MEMO

Re: Revised draft CMZ boundaries for Lower Morse Creek, Clallam County

Lower Morse Creek CMZ Modifications

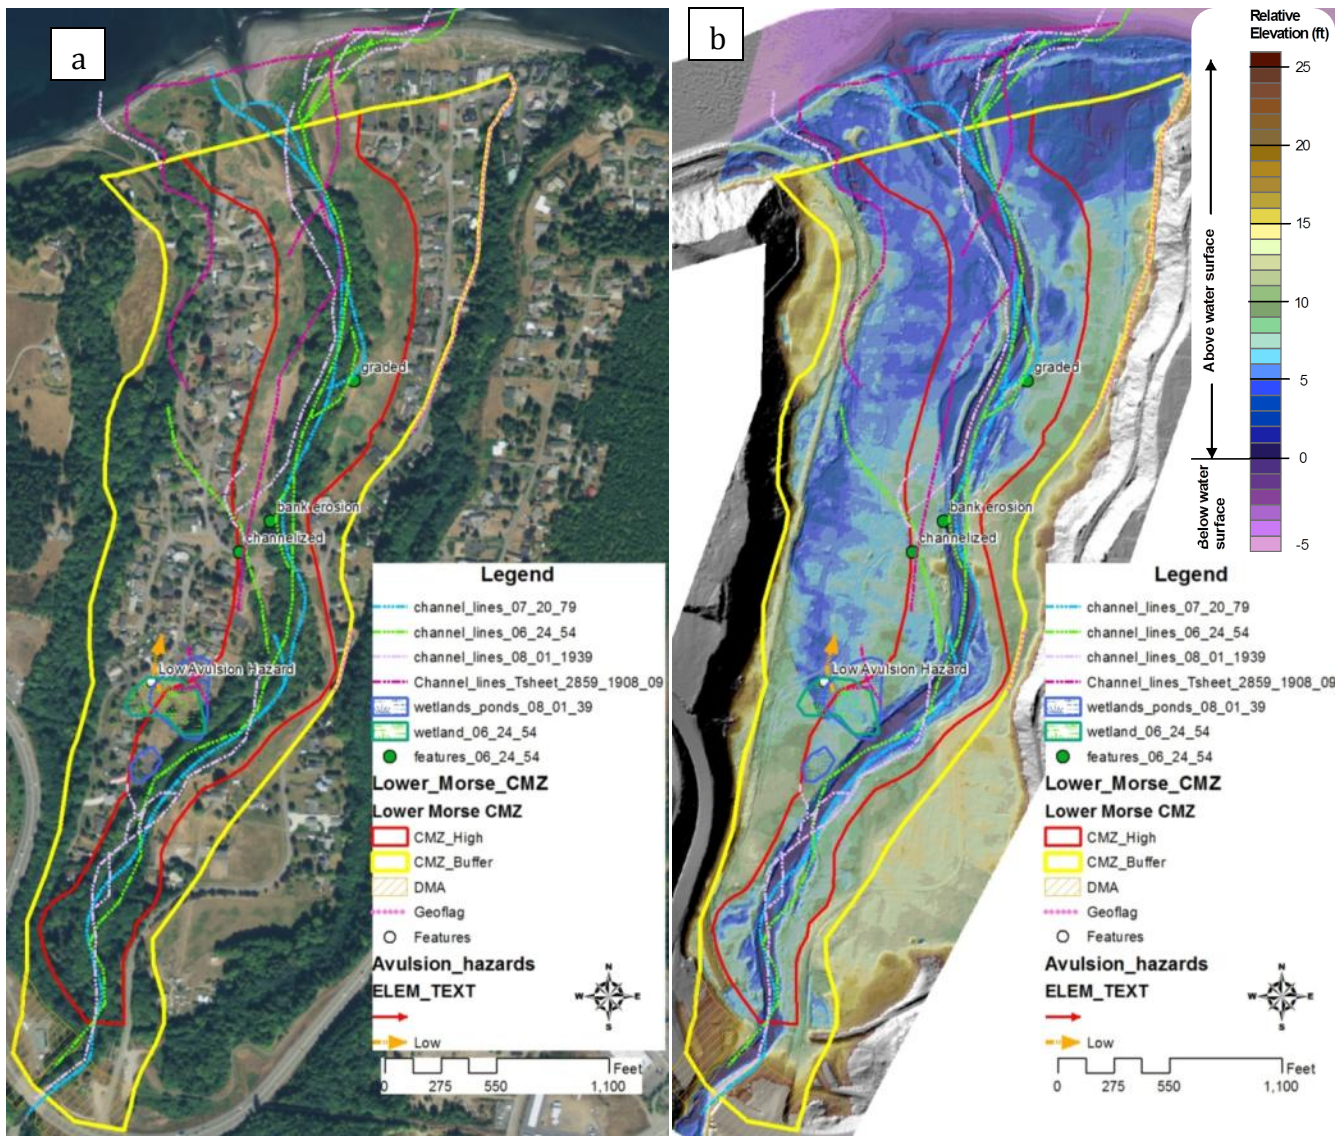
- The outer CMZ boundaries (yellow lines) are brought more stream ward than the original boundaries (Figures 1a and b).
- The CMZ is divided into a higher potential hazard CMZ (red boundary Figures 1a and b) and a CMZ buffer which has a lower potential hazard (yellow boundary, Figure 1a and b).

Currently there is very little development within the higher potential hazard CMZ. The higher potential hazard CMZ contains the stream lines from the historic air photos and T-sheet with the exception of some relic distributary channels evident in the 1954 air photo and 1908 T-sheet.

Figure 2. On river left the FEMA floodplain extends to the base of the valley wall. The relative water surface elevation model indicates that this area is lower than the valley floor on river right. The CMZ boundary (yellow line) incorporates the floodplain. Higher resolution maps are in Appendix A.

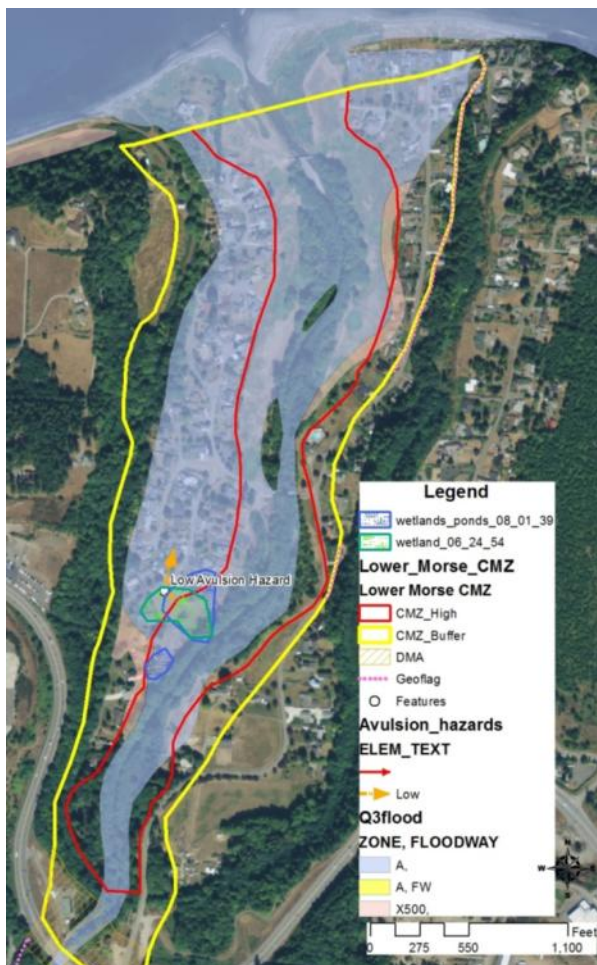
- However, if the roads are above the 100-year elevation such as Strait View Drive (Figure 2), built to withstand the 100-year flood hydraulic forces, with a public commitment to keep them intact and maintained can be considered constraints to migration (WAC 173-26-221(3)(b)). The roads within the valley are not considered barriers. Strait View Drive may be if it is maintained by Clallam County or other public agency. On valley left the Discovery Trail may also be a barrier but we don't have information on its maintenance should it fail.

- Much of the area is within the FEMA floodplain (Figure 2) and has areas only slightly higher to below the water surface elevation from the LiDAR data (Figure 1a and 3).

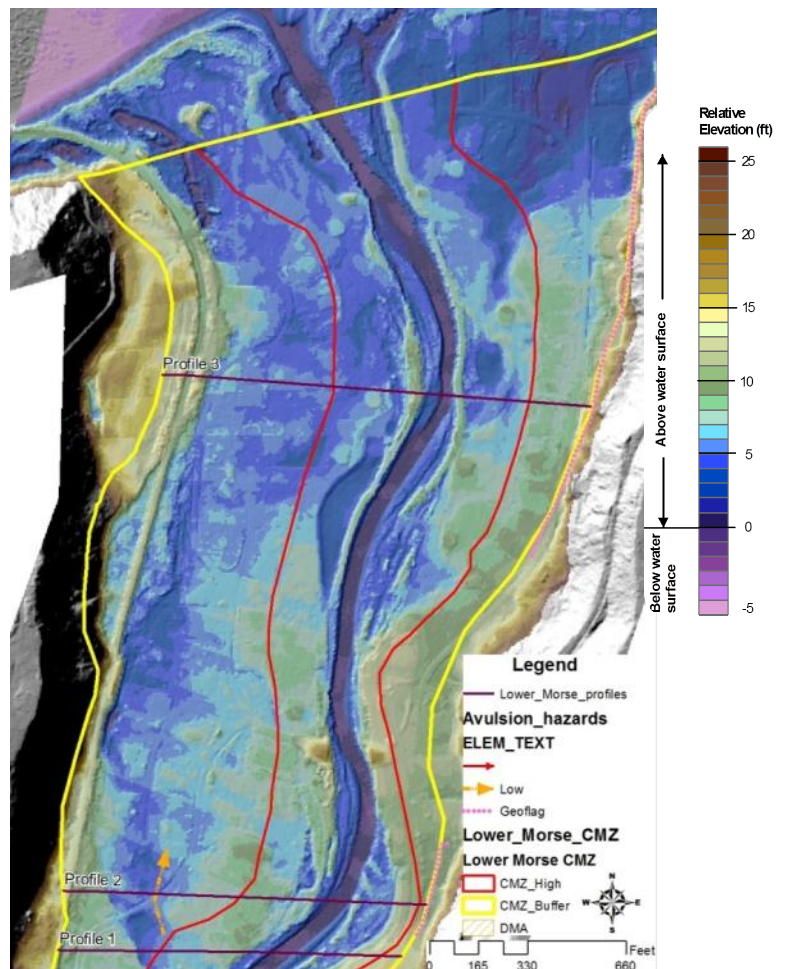
- The relative water surface elevation model and associated profiles indicate a low avulsion hazard on river left (Figures 3 and 4). The avulsion path is likely a relict distributary channel.
